# Submission on Clontarf to City Centre Cycle Route with signatures of 1,493 people

Route should use a fully segregated two-way cycle path

In pre-planning since 2012, the Clontarf to City Centre Cycle Route was supposed to provide a fully segregated two-way cycle path between the existing coastal path at Clontarf and the city centre, via Fairview and North Strand.

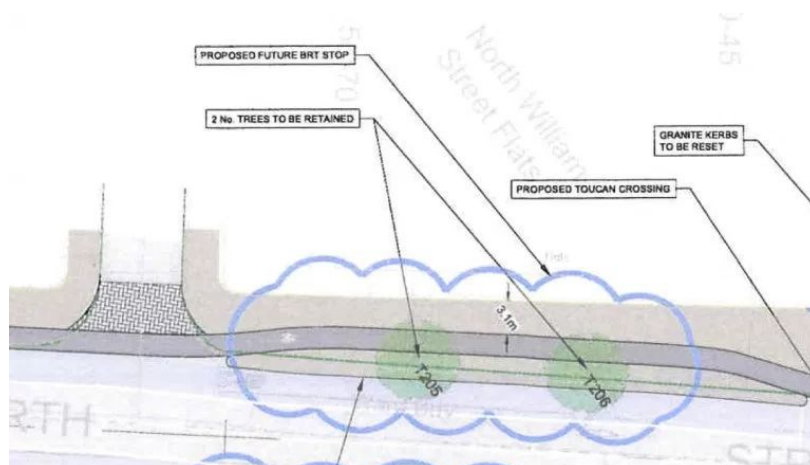
The following is an overview using the Part 8 drawings:

Nearly all along the route, areas for buses to pull in at bus stops (shown in lime green) interrupt the cycle route. The above image shows the bus stops in a lime green colour, but it also shows a future bus rapid transport (BRT) stop — where there are two green circles depicting two trees. We only know that it's a future BRT stop because we've seen pre-Part 8 drawings (partly shown below).

### Fairview and Fairview Park

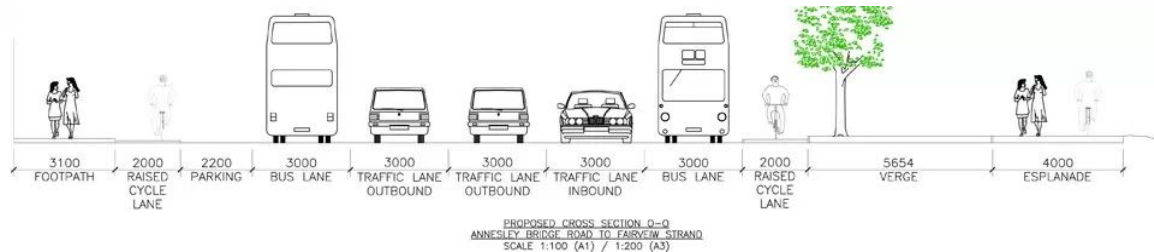
Alongside Fairview Park it is proposed to remove trees to apparently provide for space for cycling but this space could be provided for a two-way cycle path on the park side of the road with far less interventions to the mature trees or to the roadway generally.

With a two-way cycle path on the park side and the addition of London-style or Dutch-style signalised bicycle crossings for safe and attractive access, the cycle route could be installed on the park side without much changes to the retail side of the street.

The council's plan to provide for a "esplanade" (translation: a shared walking and cycling path) inside the park will suffer from the issues mixing walking and cycling already causes in the park and elsewhere.

### Buffer space

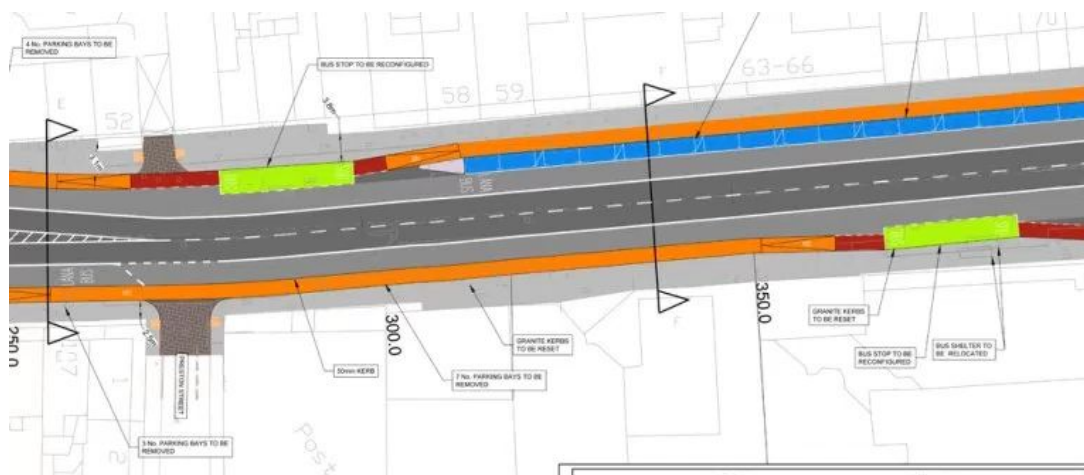
To provide buffer space between cycle paths on both sides of the road and elements of the street including bus stops and car parking would require extra space -- but, if the design used a two-way cycle path on one side of the road, then the parking could be focused on the other and only bus stops or parking on one side of the road would have to be buffered.

Buffer space of at least 0.5 metres could also be provided where the cycle path runs beside the carriageway.

## Planned Amiens Street at railway bridge - cross-section B-B

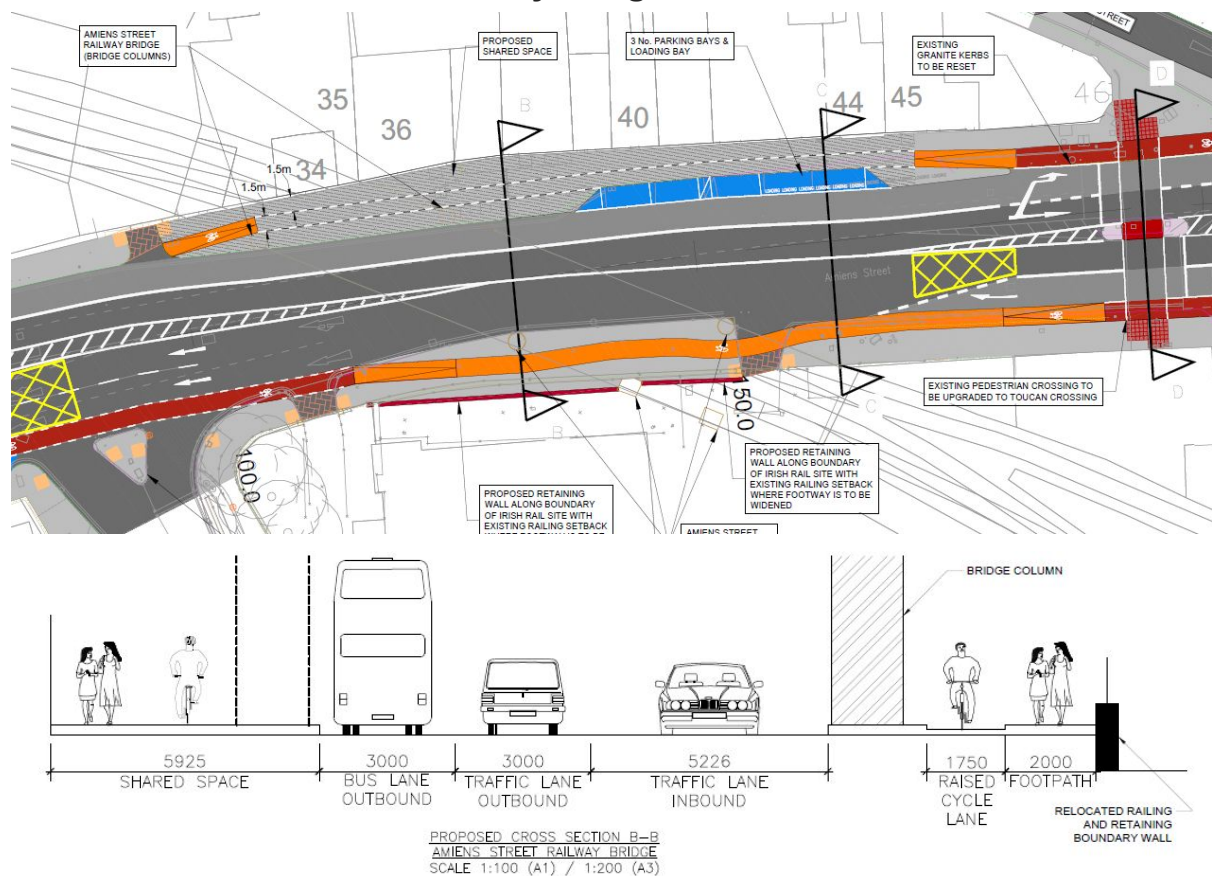
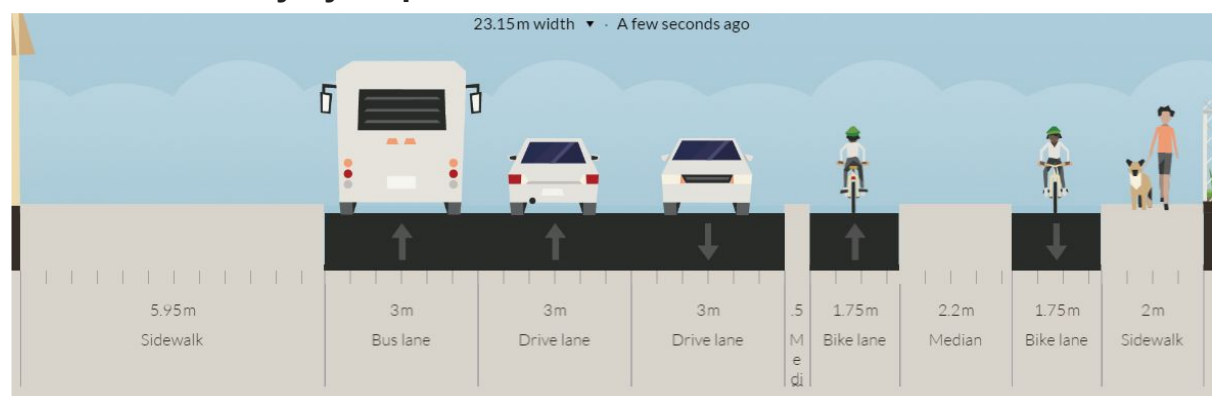
The following cross sections are examples, widths may vary, but a two-way path would allow for more space overall and a better overall quality of service.

## Planned Amiens Street at railway bridge - cross-section C-C

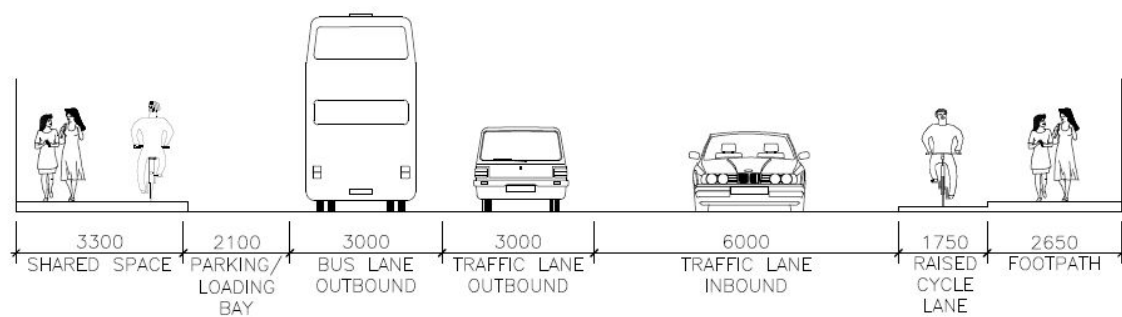
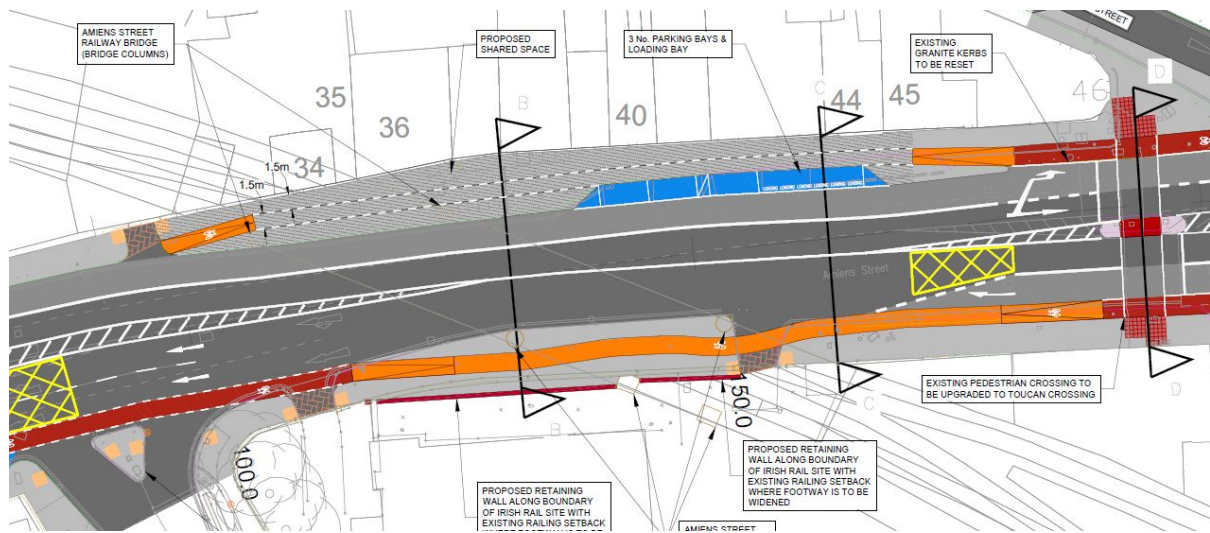
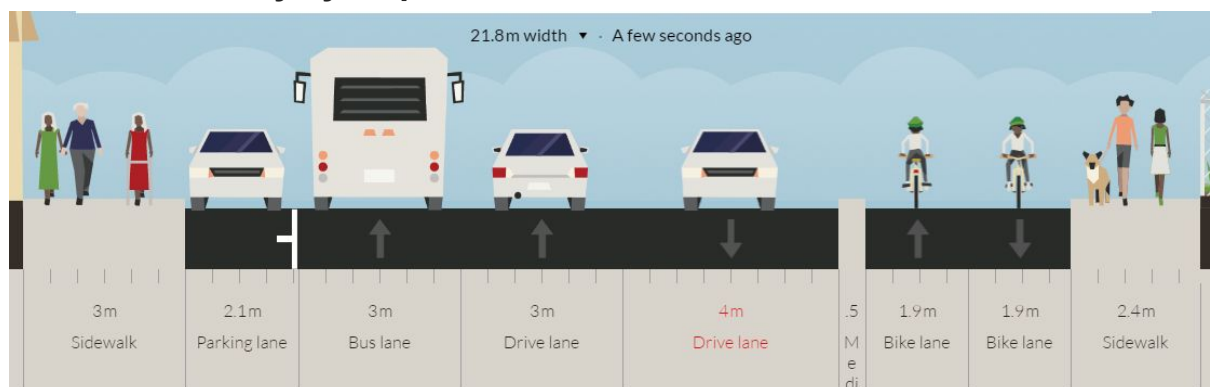
## Possible two-way cycle path

## Planned Amiens Street at railway bridge - cross-section D-D

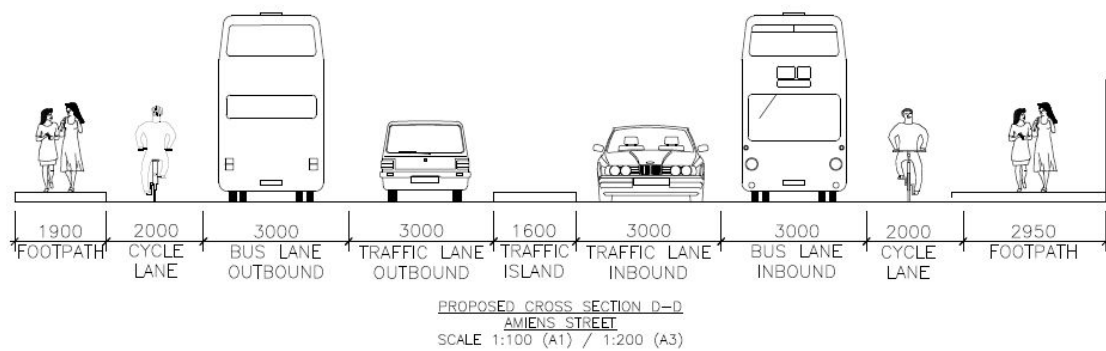
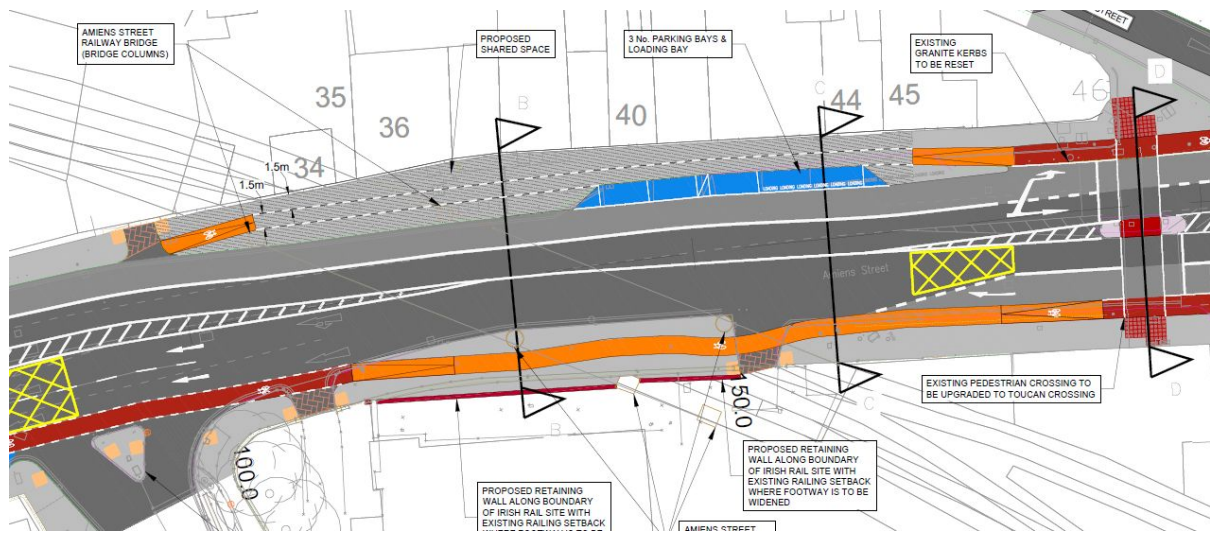
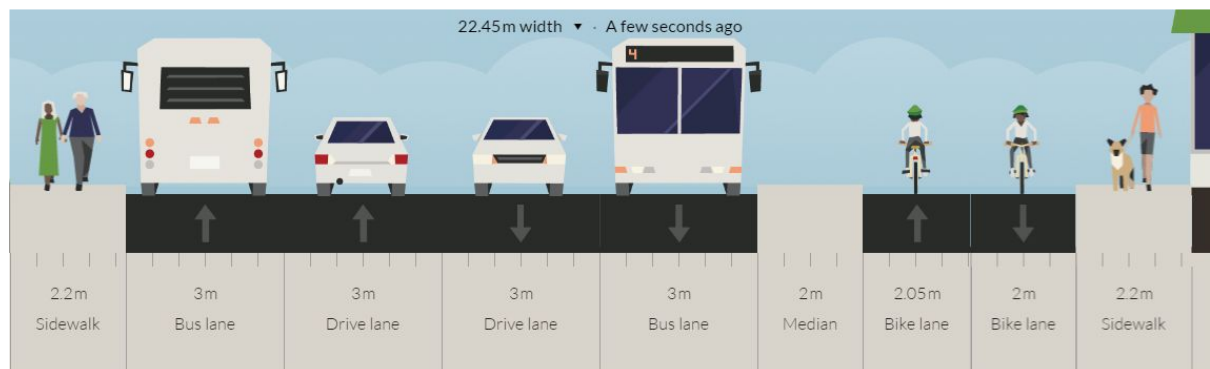
## Possible two-way cycle path

## Planned Amiens Street north of railway bridge - cross-section E-E

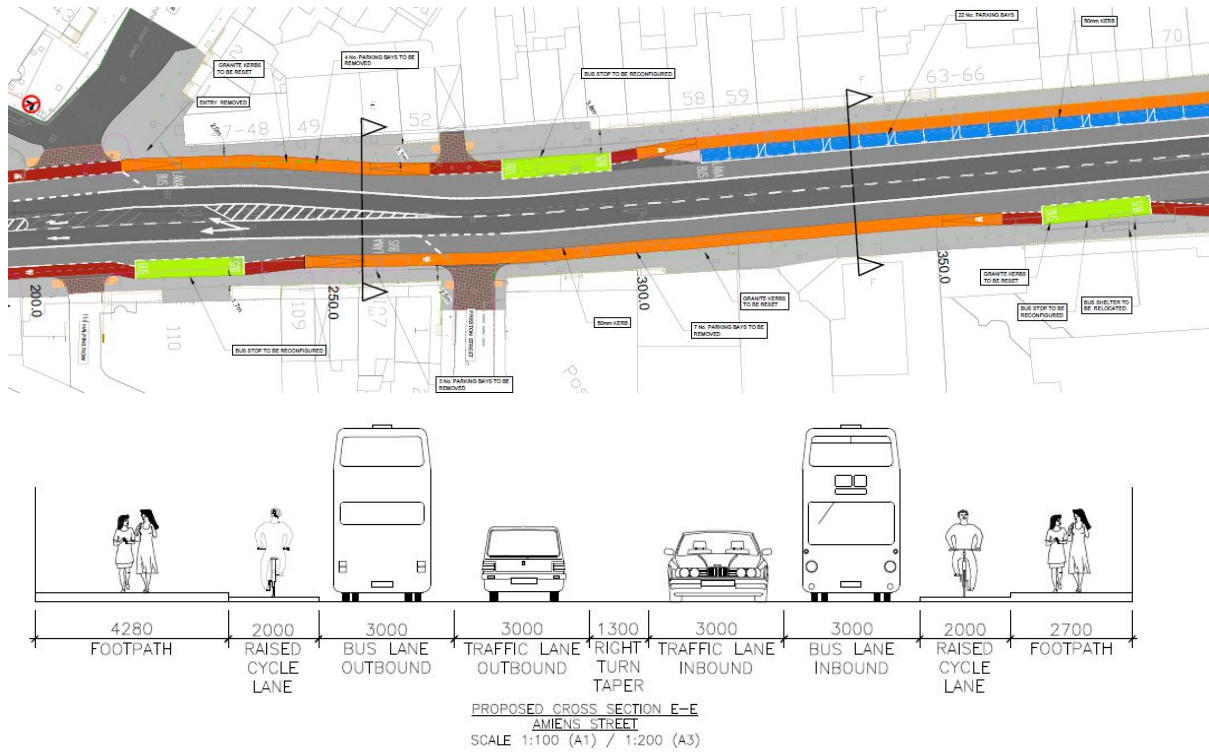
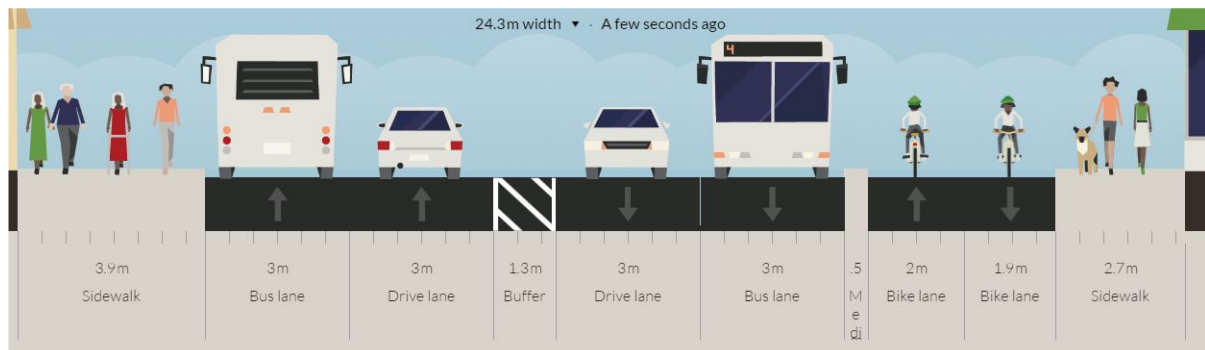
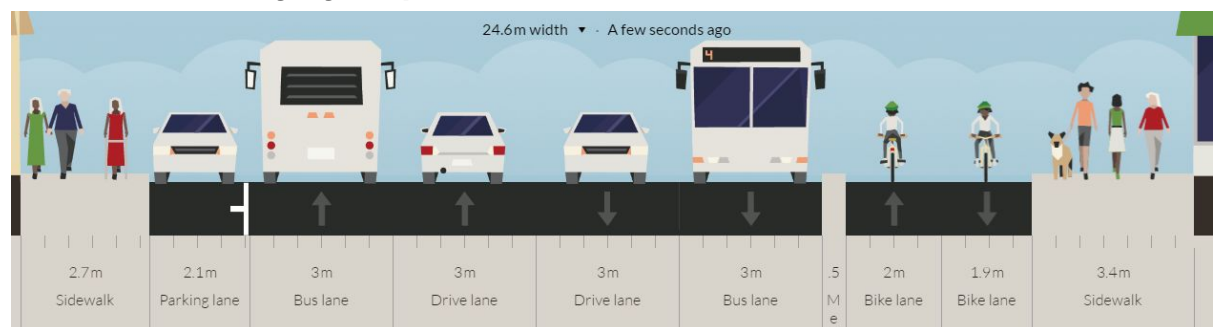
## Possible two-way cycle path

## Planned Five Lamps / North Strand Road - cross-section G-G

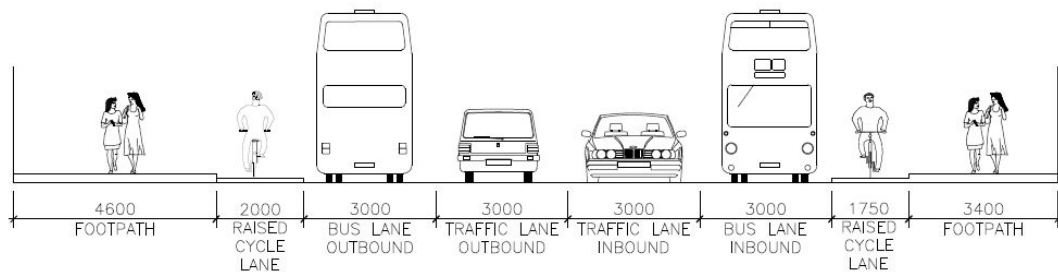
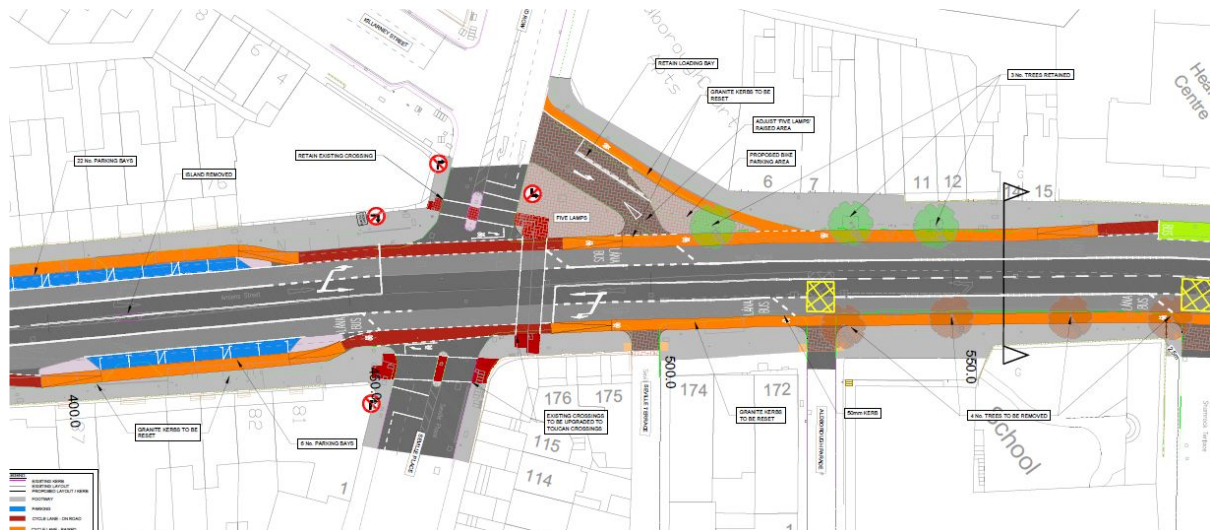
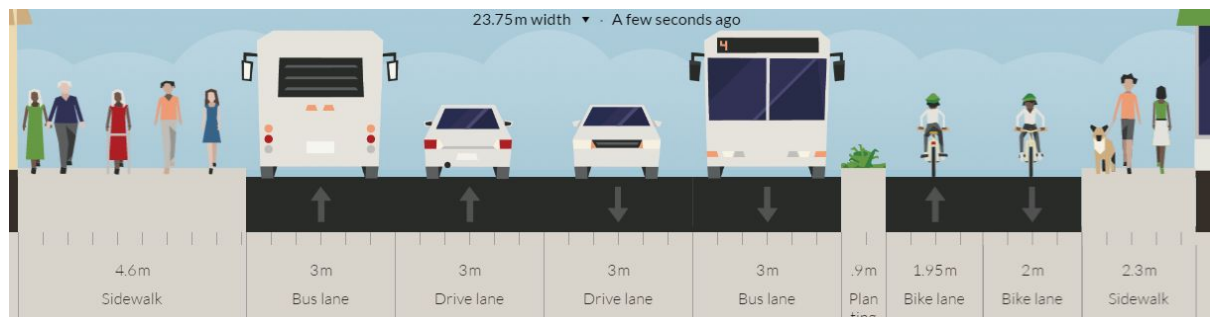
## Possible two-way cycle path

## Planned North Strand Road at Royal Canal - cross-section H-H

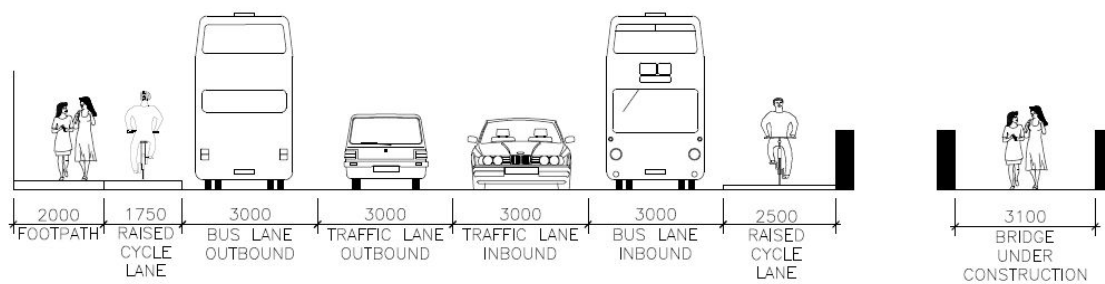
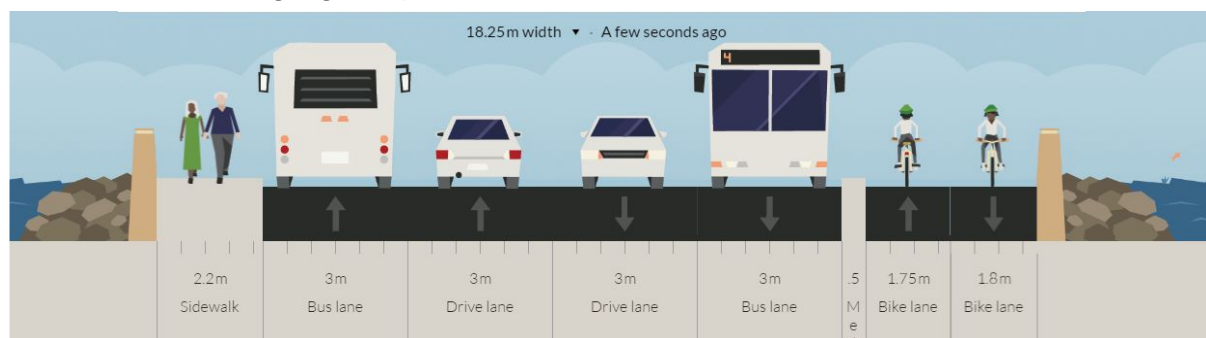
## Possible two-way cycle path

Planned at Tolka River - cross-section N-N

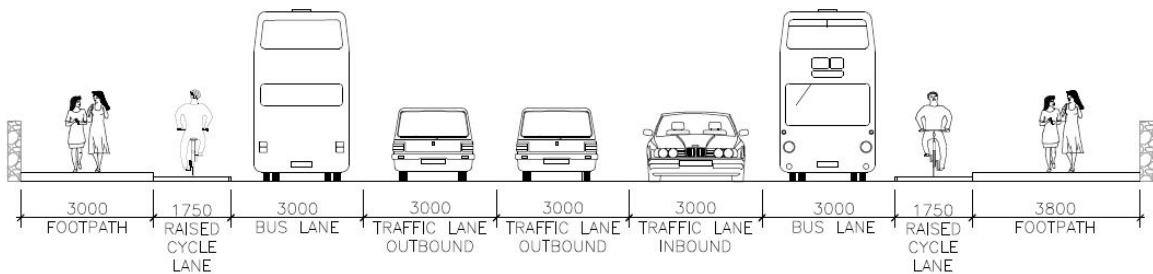
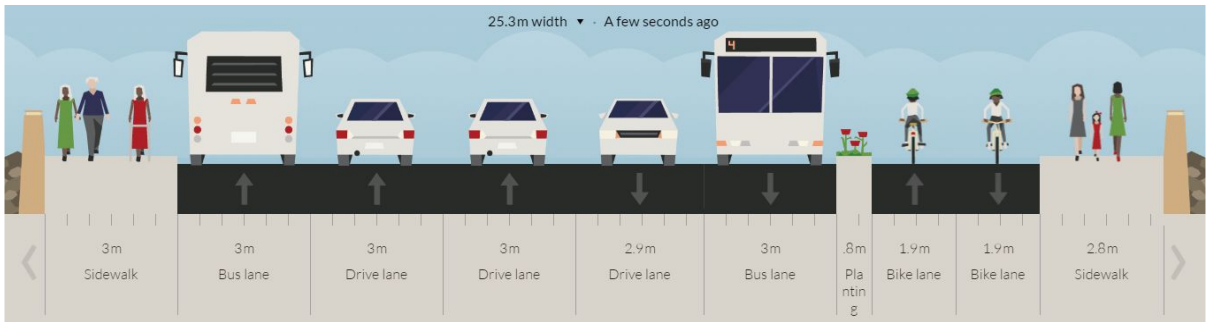
Possible two-way cycle path

## Planned at Fairview / Fairview Park - cross-section O-O

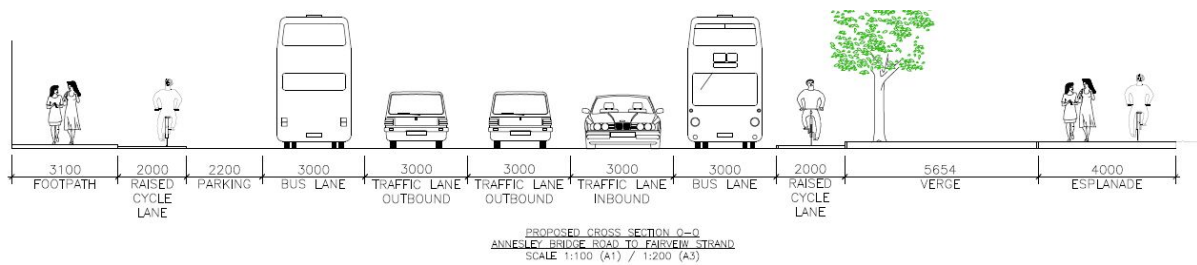
## Possible two-way cycle path

*Note: This is just an example cross-section, exact location of trees etc would need to be determined.*

## Planned at Fairview outside shops / Fairview Park - cross-section O-O

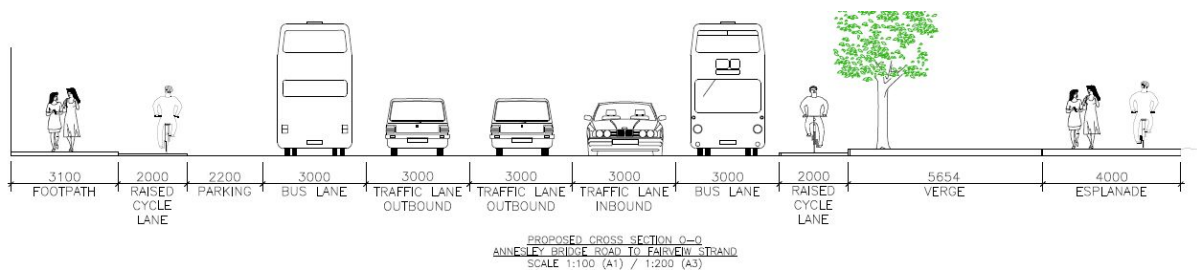
## Possible two-way cycle path

+ possible bicycle street / cycling-friendly service street on shop side

*Note: This design would include removing mature trees, but only with a vision of adding trees to both sides of the main carriageway and providing separation between the main carriageway and the access and parking to shops.*
